ADDENDUM #3

Lewis and Clark Caverns State Park Comfort Station Septic FWP #7196303

Near Cardwell, Montana
December 22, 2021

Figure 3-1

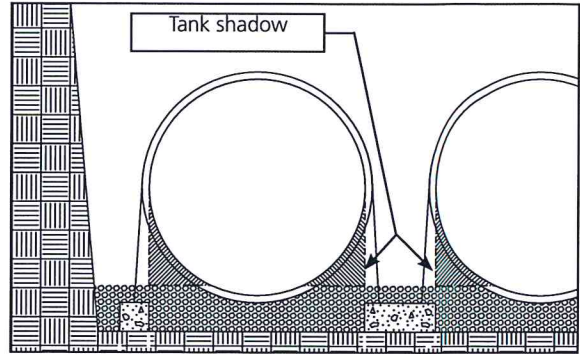
Note: Be sure there is proper compaction within the tank shadow. (See FIGURE 3-1.)

- 3.1.1.1. It is imperative that the backfill material is worked under the tank body and dome so that the tank is fully supported (that is, so there are no voids under the tank and the material is properly compacted).
 - 3.1.1.2. This area of backfill may need to be compacted by hand using a nonmetallic probe.
